PLAN COMMISSION MEETING NOTICE AND AGENDA Thursday, April 18, 2019 7:00 PM

Common Council Chamber ~ Pewaukee City Hall
W240 N3065 Pewaukee Road, Pewaukee, WI 53072

Project Name: KD Glass rezoning, Comprehensive Master Plan Amendment, Certified Survey Map and Site & Building Plans

CERTIFIED SURVEY MAP NO. _____

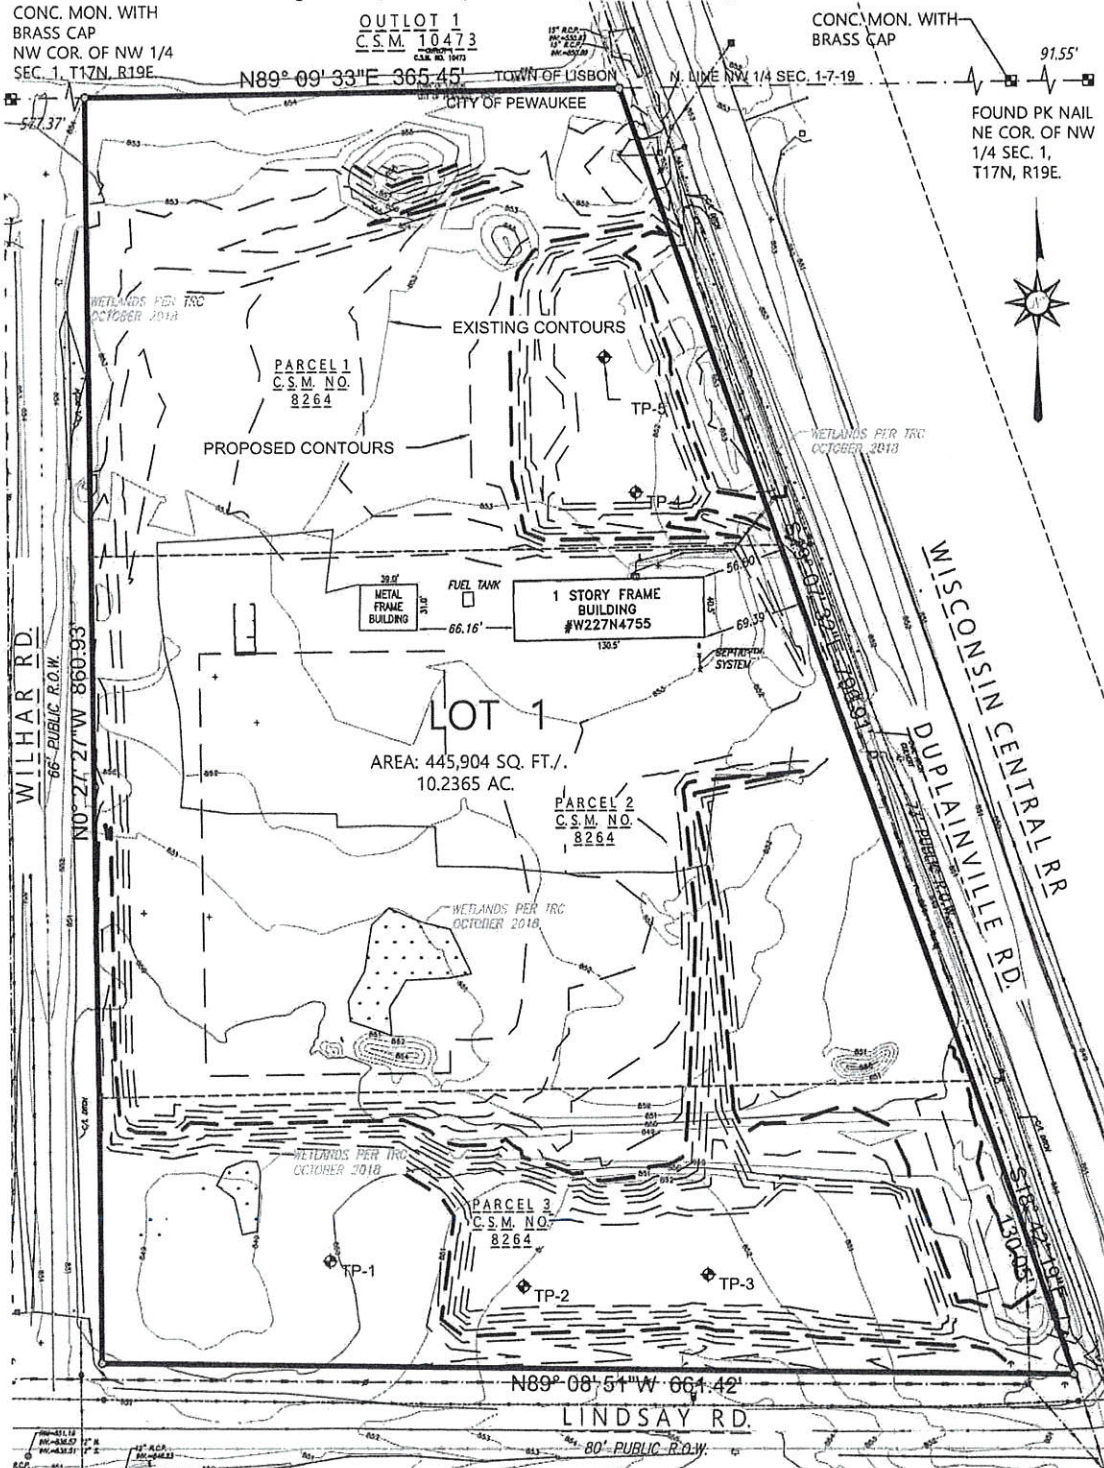
The CSM combines the three existing parcels into a single lot. Staff is recommending the following conditions be met to the satisfaction of the City Planner and prior to recording the CSM with the Waukesha County Register of Deeds:

- Per Section 18.0602, the proposed lot lines to be removed shall be labeled as “previous lot line – to be removed.”
- The following information shall be shown on the face of the CSM as required by Section 18.0603b:
 - Setbacks or Building Setback Lines required by the Plan Commission or other City or County Ordinances;
 - Utility, drainage, and access easements; and
 - Date of the CSM.
- A 30-foot wide planting easement shall be illustrated along the south property line per Section 18.0401m(2). The easement shall include a note requiring that the easement be reserved for the planting of trees and shrubs, and the building of structures within the easement is prohibited.
- The Plan Commission Secretary name shall be revised to Brandon Bergman, Secretary.

CSM No. 8264 states that the storm water easements are intended for retention basins. The proposed development plan includes improvements within the north easement (to be released as conditioned above) and parking and drives within the easement located at the southwest corner of the property (recommended to remain). Staff questions whether any development should occur within these easements other than those improvements related to storm water retention.

As such, staff recommends that the 70-foot wide storm water retention easement be revised to locate all parking and drive areas outside of the easement, prior to recording the Certified Survey Map with the Waukesha County Register of Deeds. This would shorten the length of the easement by approximately 40-feet.

Klein Dickert Revised Site & Building Plans

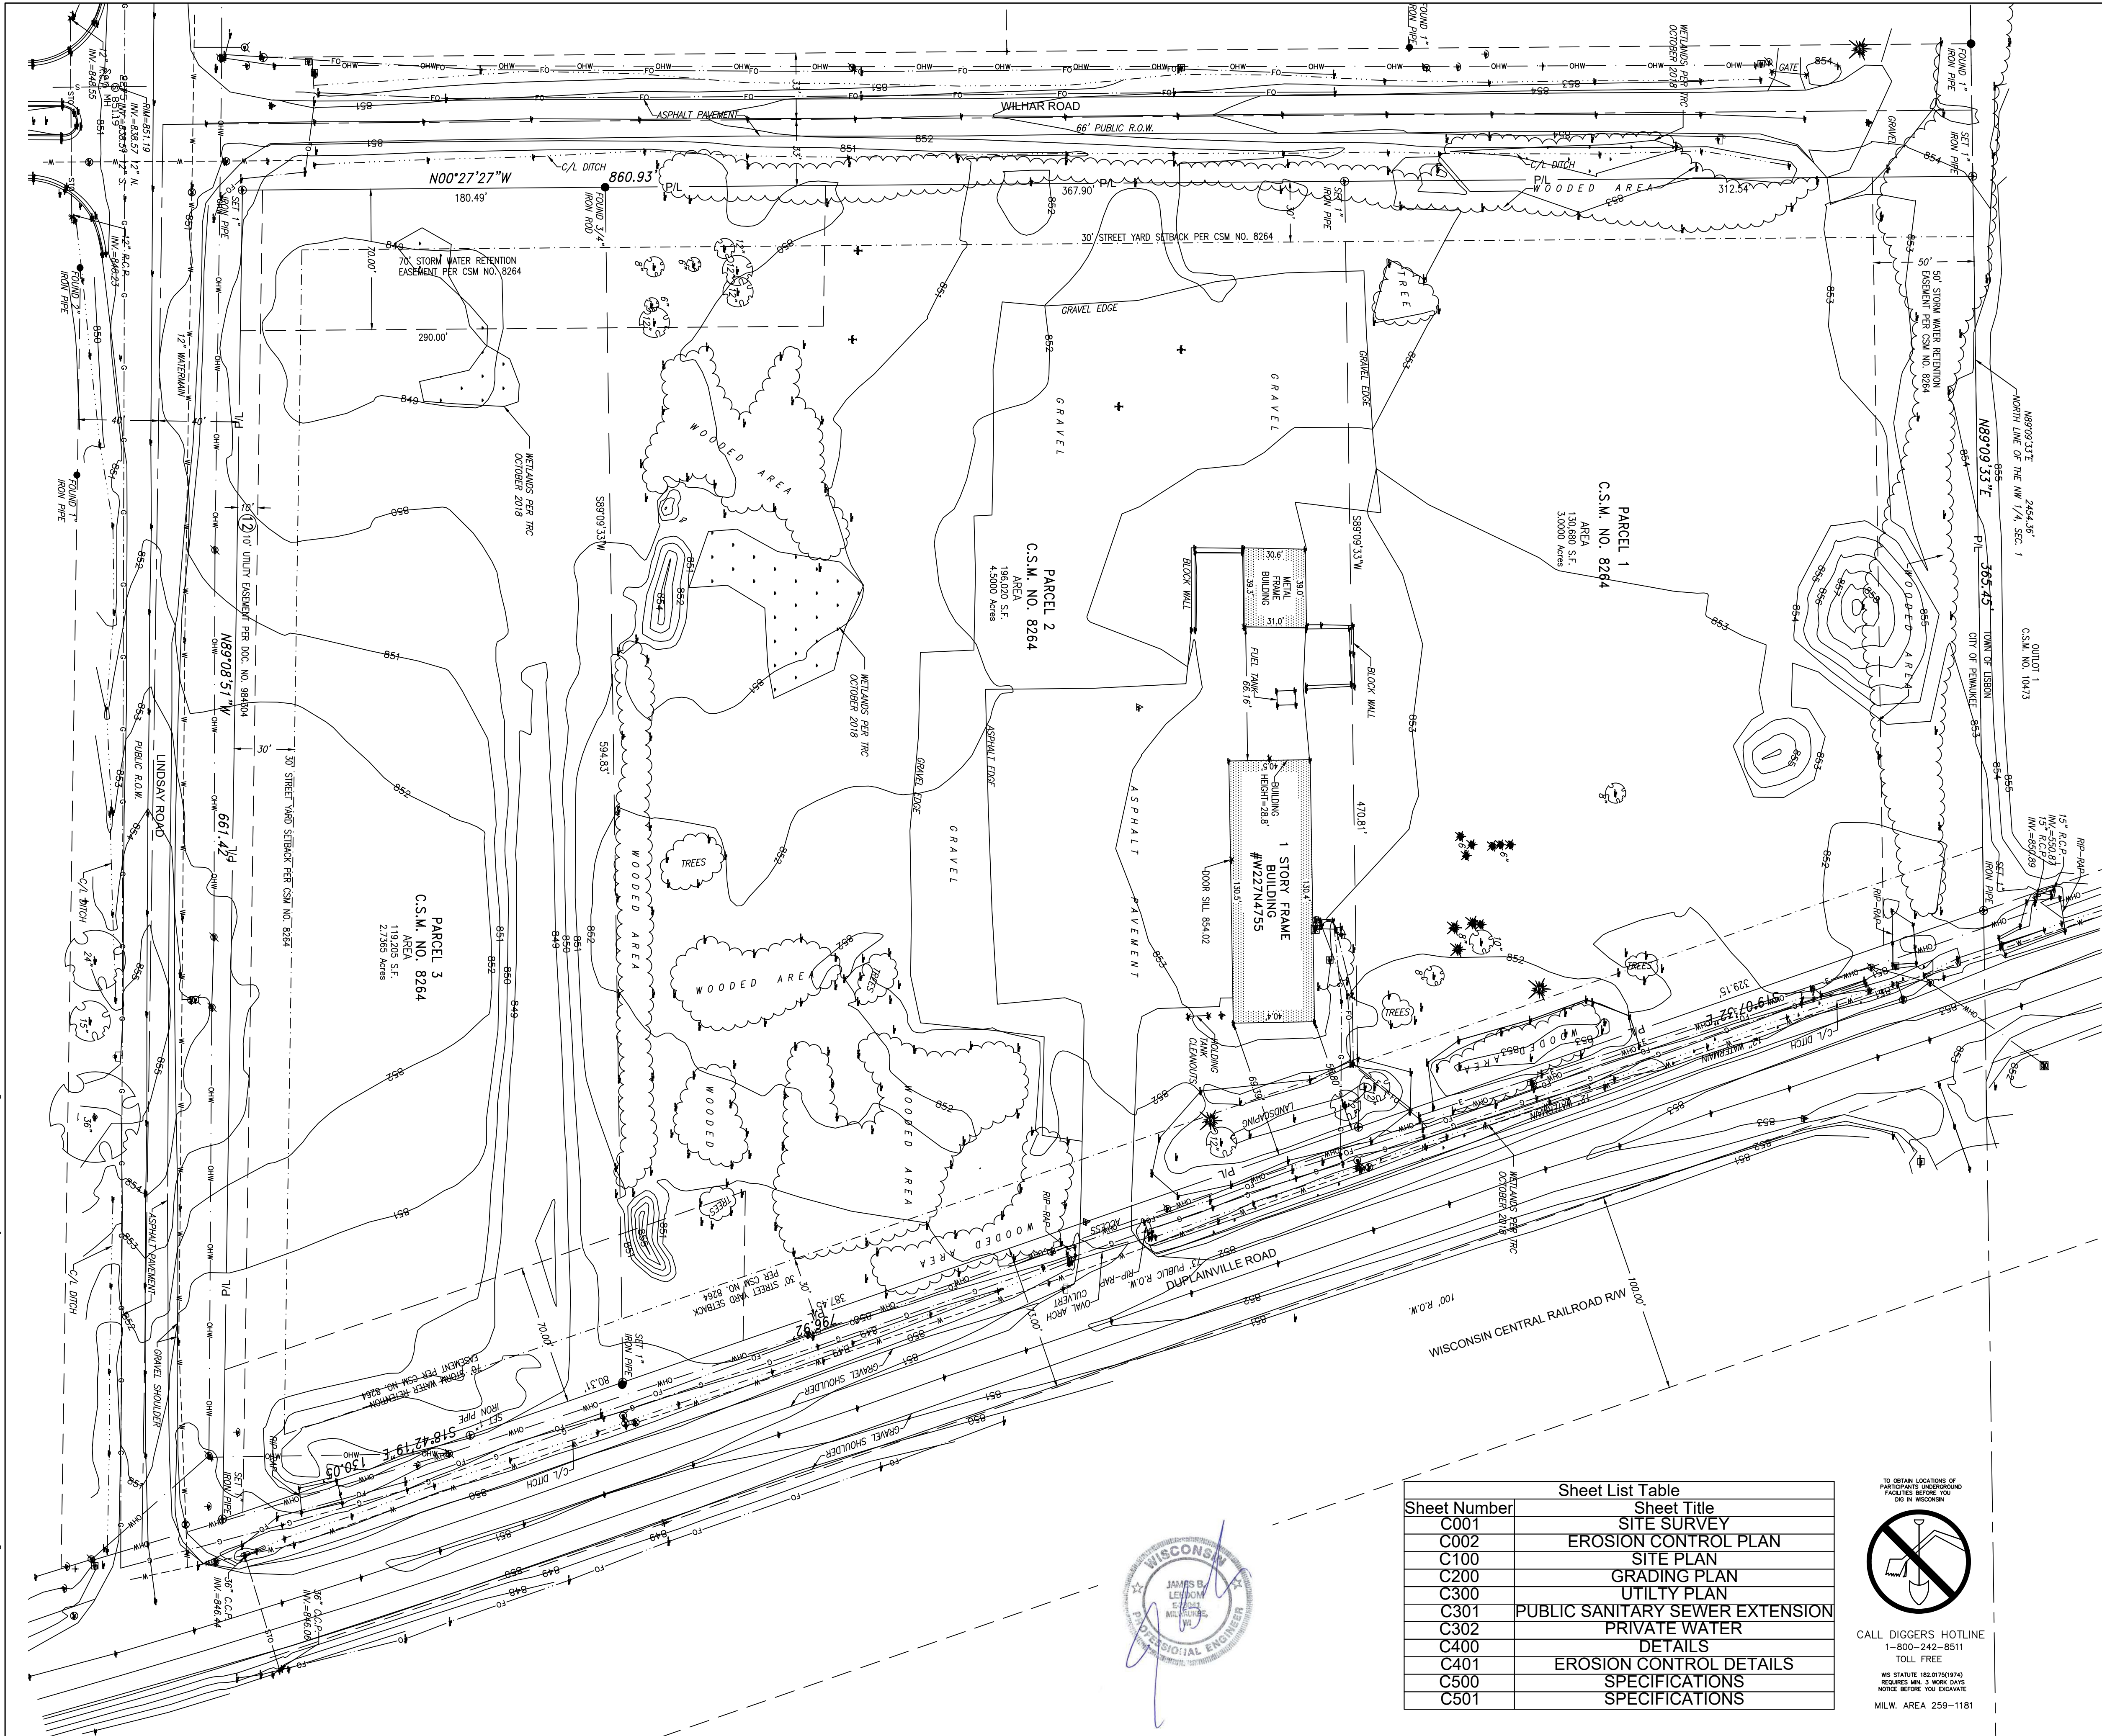
The site plan includes 82 parking spaces, including 3 ADA accessible spaces. This equates to a parking ratio of approximately 1.5 parking spaces per 1,000 square feet of gross floor area. The Zoning Code, as a guideline, suggests one space per two employees in a 12 hour period. With 40 employees, 20 parking spaces would be suggested.

The applicant has provided a preliminary landscape plan, which includes mostly existing landscaping. The applicant has noted that existing nursery stock will be utilized from the previous landscape contractor; however, they have not yet fully inventoried those plantings to apply them to a landscape plan.

As such, staff recommends submittal of a detailed landscape plan, for Plan Commission review and approval, prior to issuance of a Building Permit.

Staff has indicated to the applicant that dumpsters, loading areas and truck docks must be screened. In addition, a 30-foot landscape easement along the south property line is recommended on the CSM, and staff noted that particular attention be made within this area to provide a buffer to the existing single-family residential development to the south.

A Lighting Plan has not yet been provided; therefore, staff recommends a detailed lighting plan, including a photometric plan and cut sheets/catalog pages of all light fixtures, shall be submitted for City Planner review and approval prior to the issuance of a Building Permit.

Road appear to be decorative glass doors; however, the label on the plans incorrectly indicate white doors.
